Green Lake North LLC

SDCI# 3033823-LU

**NORTHEAST DESIGN REVIEW BOARD:
RECOMMENDATION MEETING #2**

Date: 2/24/2020

Level 1 Plan

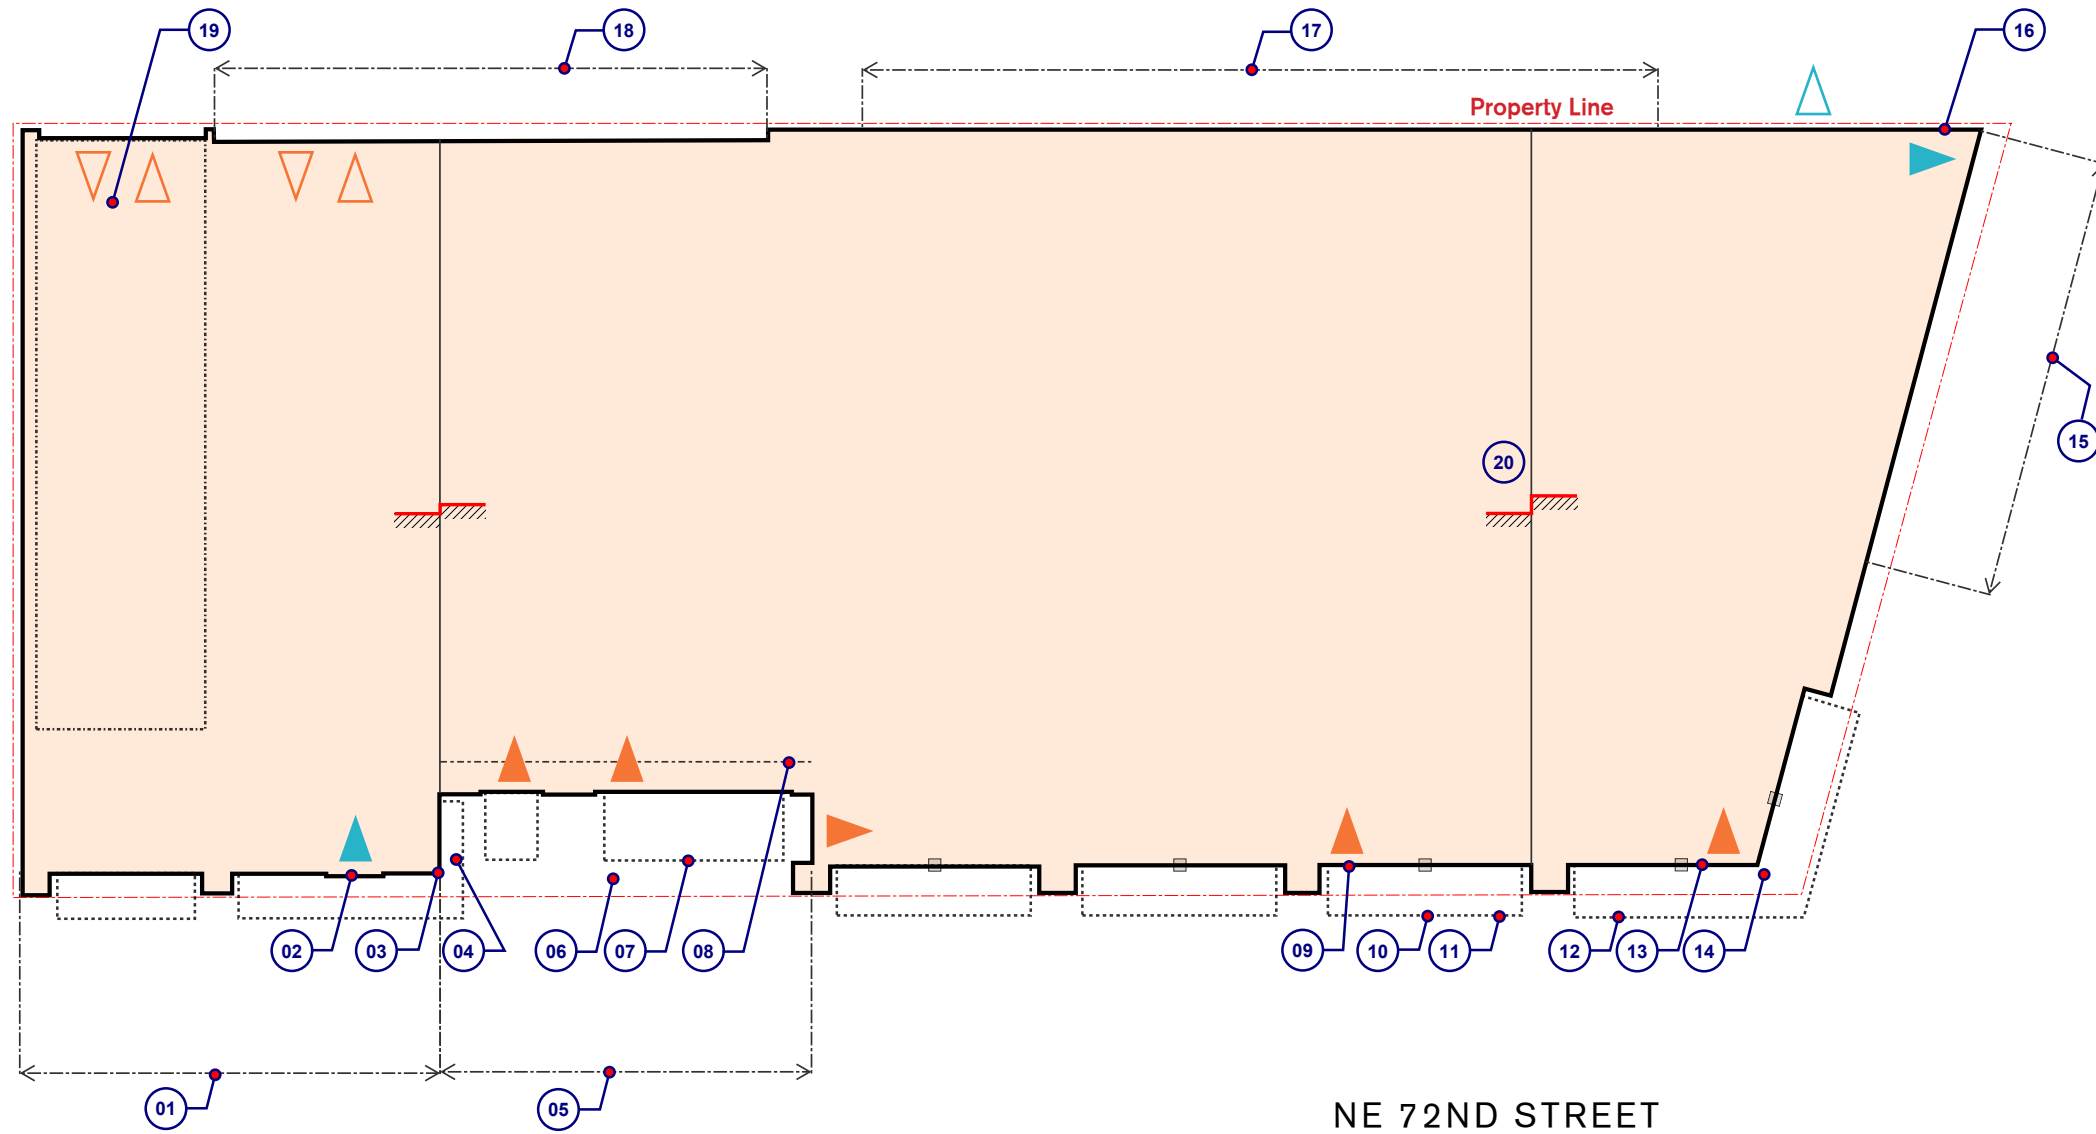
Summary for Grade & Lower Levels (L1-2)

1. Simplified materials – change from concrete to brick
2. Adjusted location of entry and increased prominence
3. Increased visibility into Residential Lobby
4. Enlarged canopy
5. Changed recess material to express L1-L6 façade (break podium datum)
6. Reduced court, increased planting
7. Feature canopies at commercial entries
8. Balconies above
9. Introduced new entries
10. Revised storefront:
 - Increased glass
 - Reduces louvers
 - Highlighted primary frame
11. O.W.P Canopies
12. Feature canopy at corner
13. Corner entry
14. Increased visibility into Commercial space
15. Introduced windows (eliminated plant walls)
16. Chamfer corner
17. Introduced louvers
18. Recess/material intro
19. Ramp slope lessened
20. Stepped floor plate

Street level design improvements: Alley side wall at L1

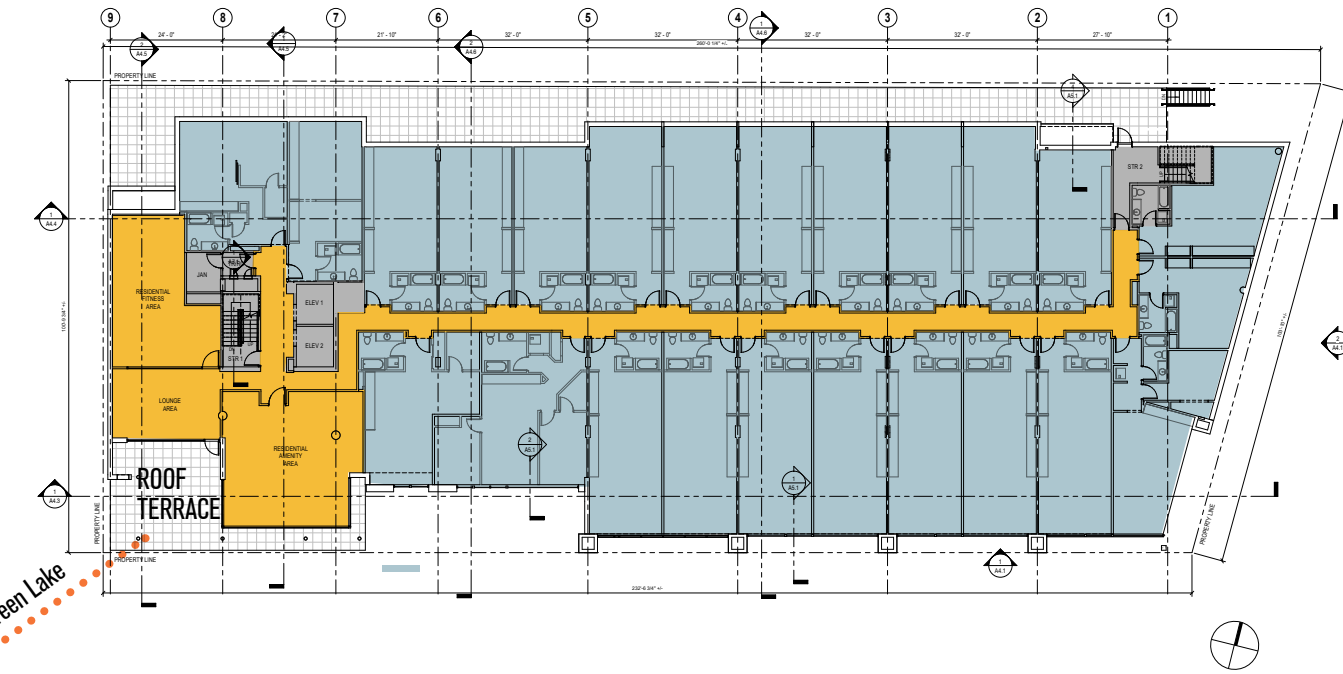
Opaque wall at alley presented harsh L1 facade to neighbors immediately to North (5.a)

Garage loading bay entry portals proximity to property line along alley forced vehicle maneuvering to cross neighbors property at opposite side of the alley. (5.a)

18 Recessed west end of alley wall off property line to afford adequate truck back-in maneuvering within alley width dimension. Established an area of north L1 wall which can accommodate material change and/or artwork.

18 Relocated louvers for tenant mechanical system air from street-side to here

Level 3-7 Plan (Level 3 Below)

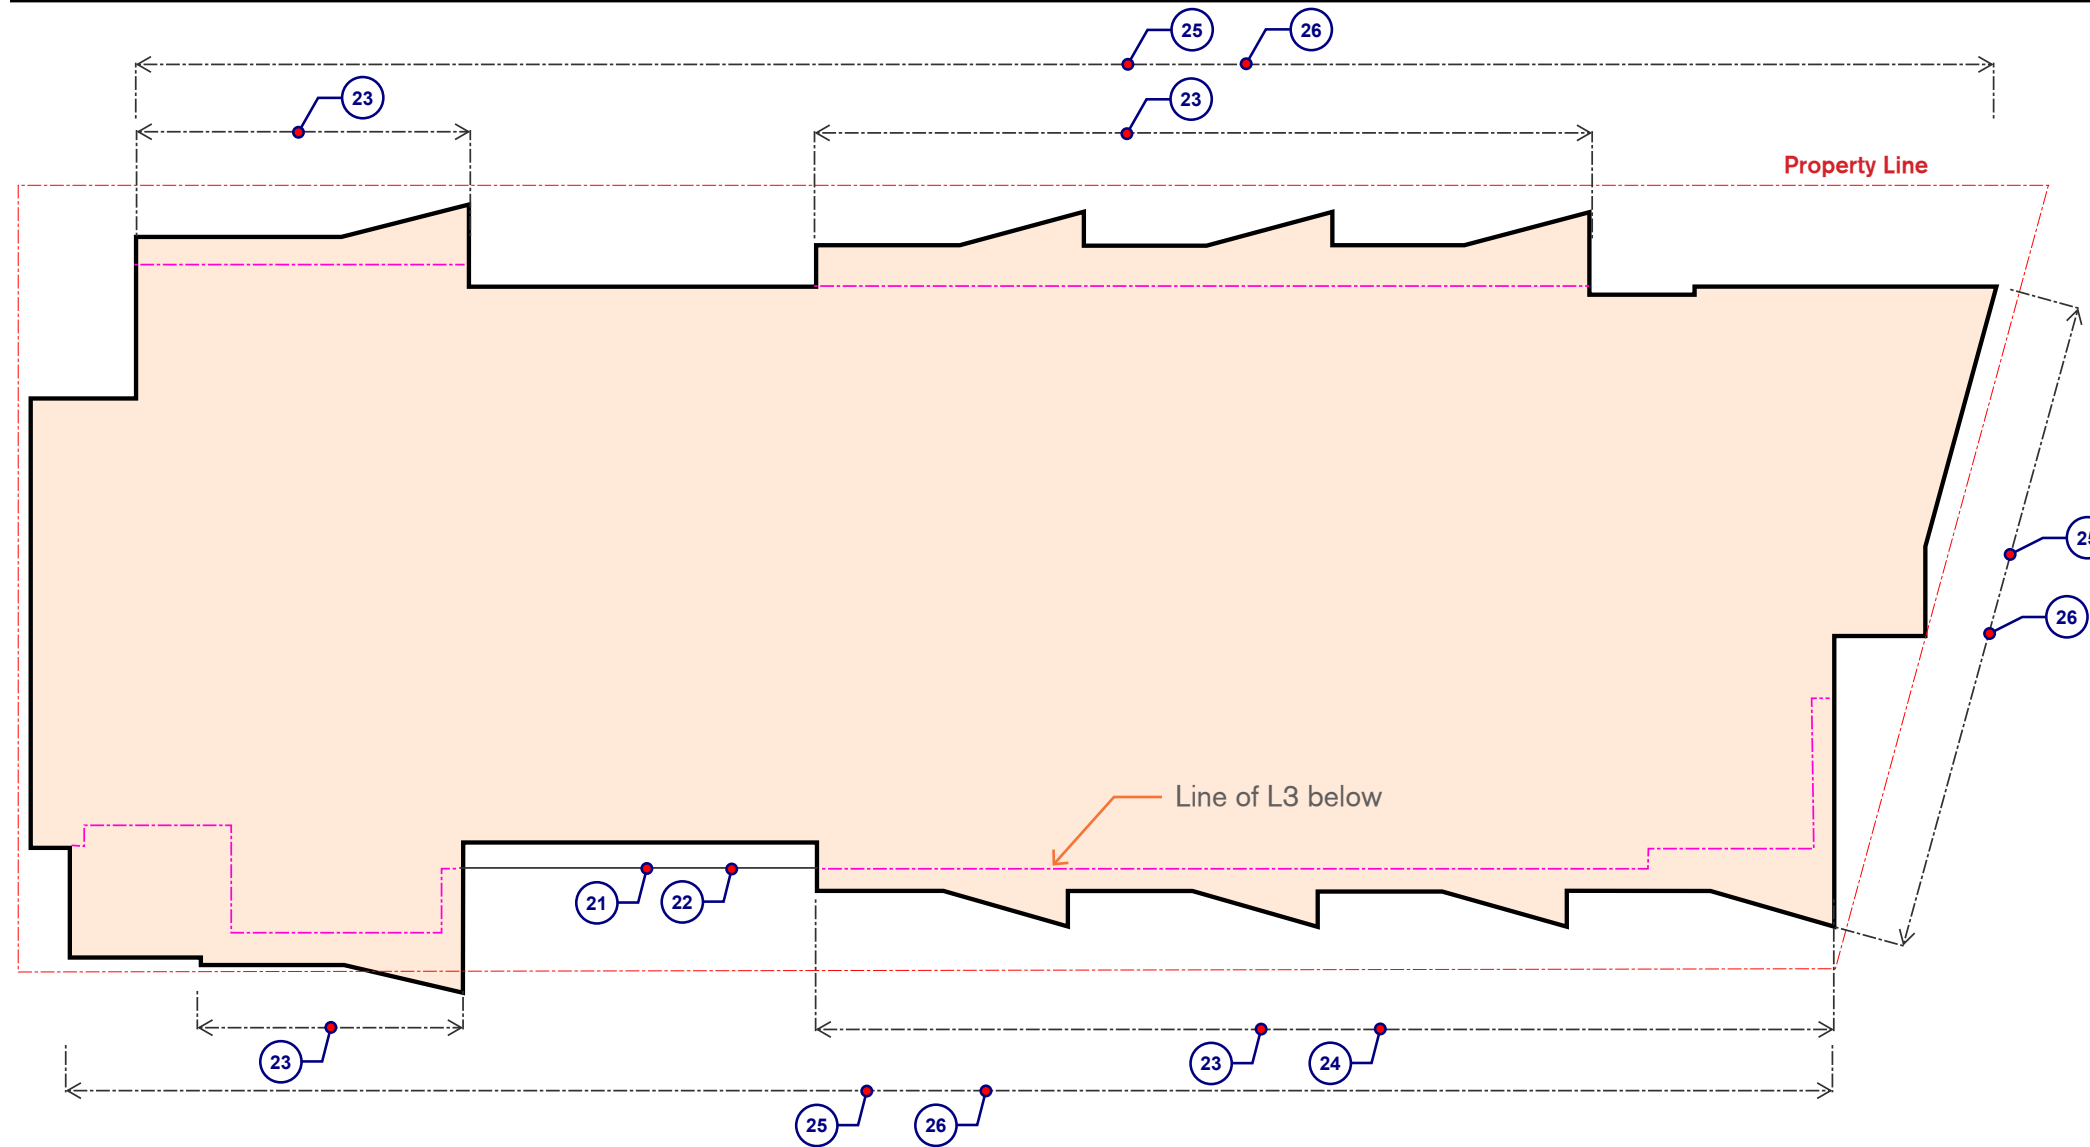
Summary for Upper Levels (L3-7)

- 21. New L3 balconies at adjusted façade below
- 22. Simplified material palette
- 23. Increased angle of canted façade
- 24. Top floor articulation
- 25. Aligned windows and railings
- 26. Simplified materials and color palette

Comparative South Elevation

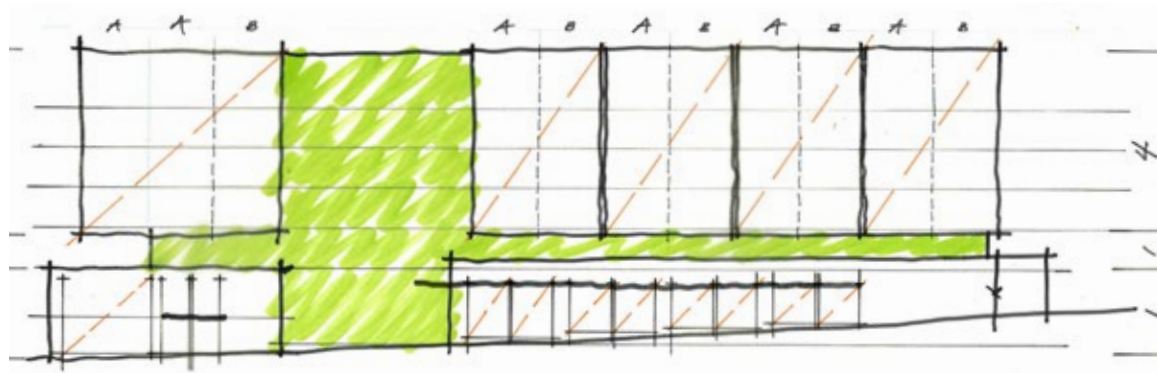
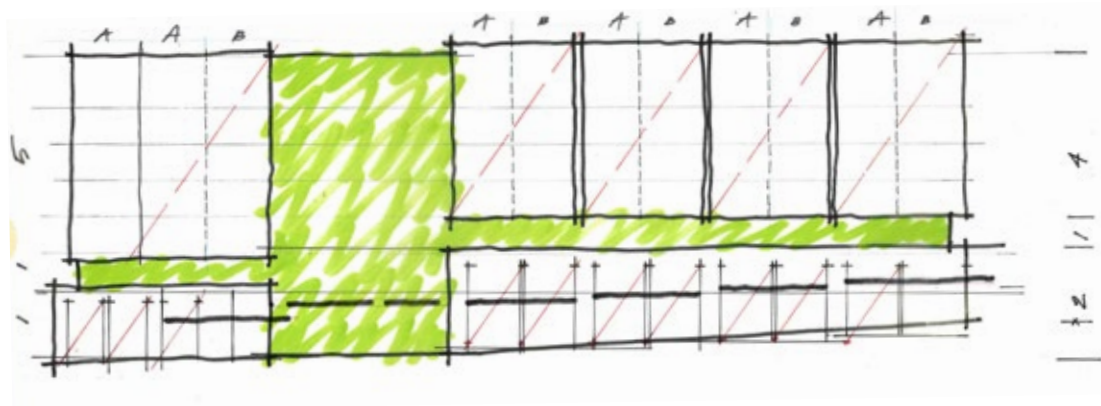
As a response to a recommendation of the board, we are illustrating how closely the current design follows the sketch artistry from EDG

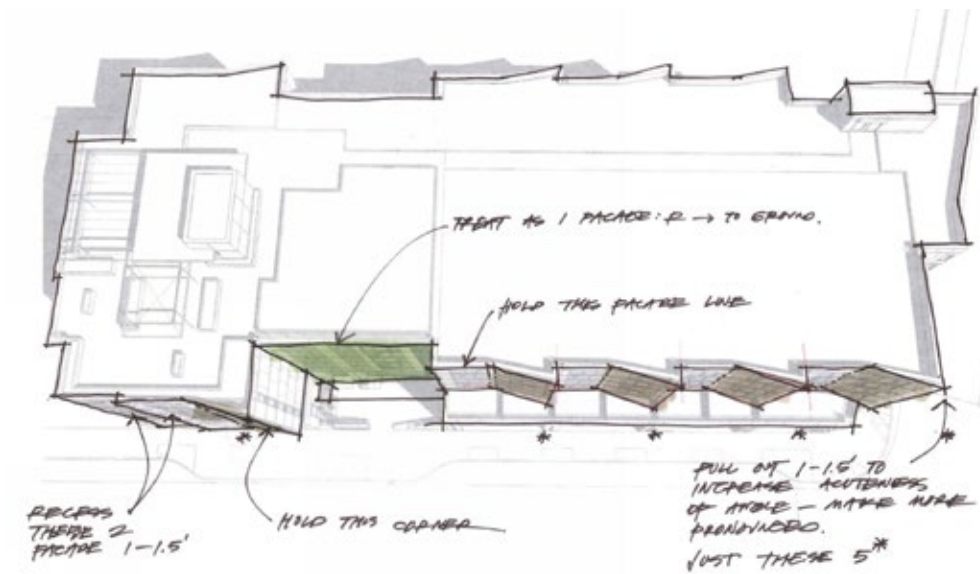
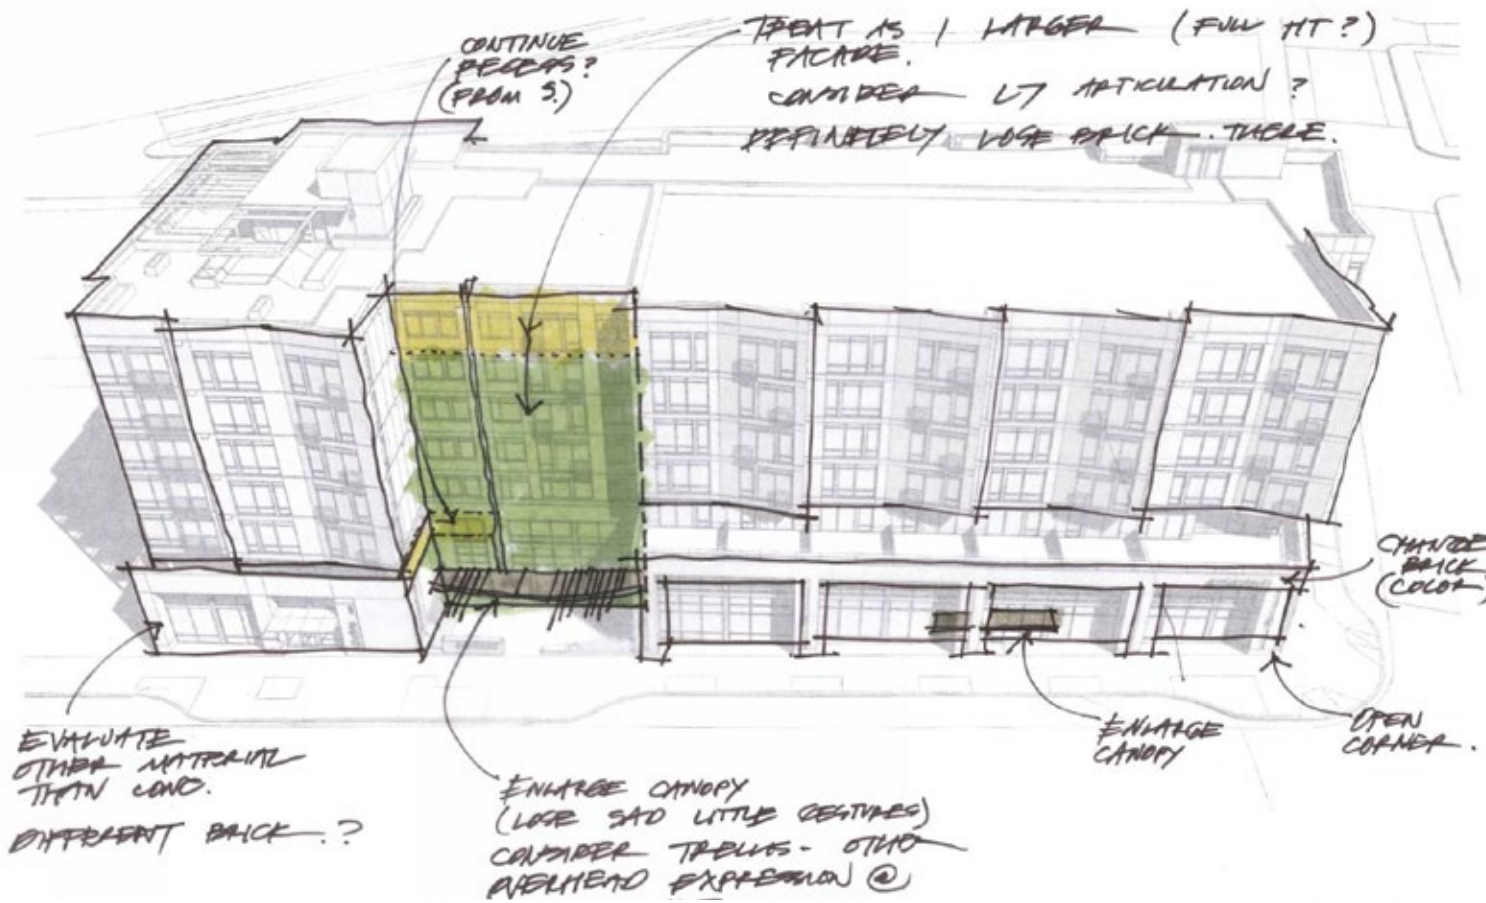
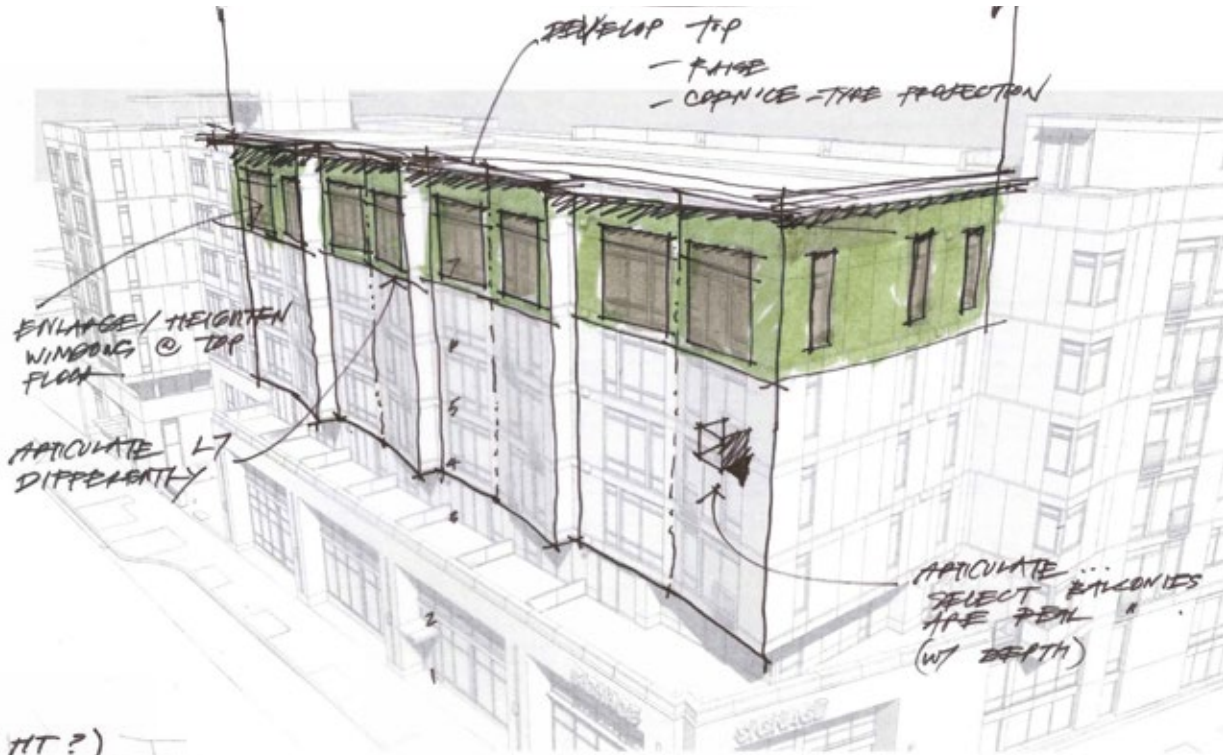
This page and the next shows the evolution of our design in response to DR comment (2. Façade)

Raising the building height and increasing the overall volume unnecessarily does not conform to efficient use of resources, materials and available budget for this project. The negative impact on neighboring properties and appropriateness of an edge zone site also does not conform with Ownership's relationship to the Greenlake community.

STEPPING BACK UPPER FAÇADE

Solutions which pulled back the building at the top were studied but did not result in a consistent or well-resolved massing. Additionally, the reduced floorplate did not yield adequate market size units. Ultimately the design team felt the 4 over 1 over 2 massing and façade expression was superior to what seemed an overly articulated form by recessing the top floor.
